September 2015

9xx Series Cameras Firmware

General Description

Day / Night Switching and VMD

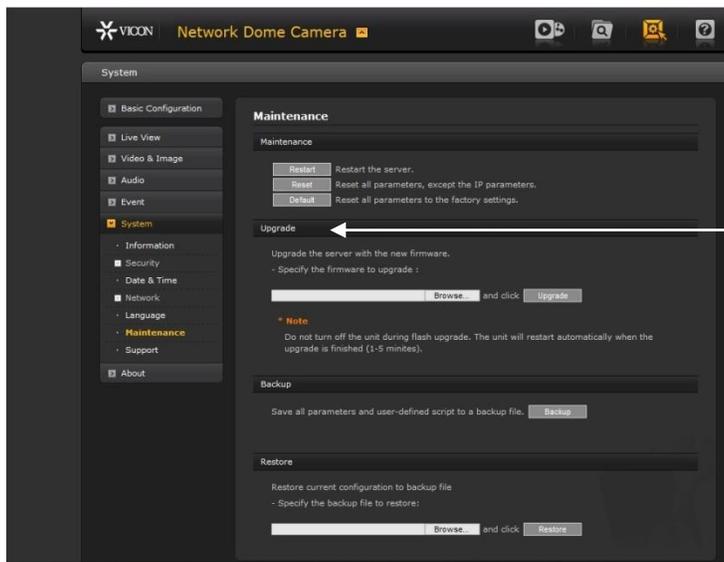
Added a delay following a switch from day to night mode or back so the switch won't trigger a VMD alarm.
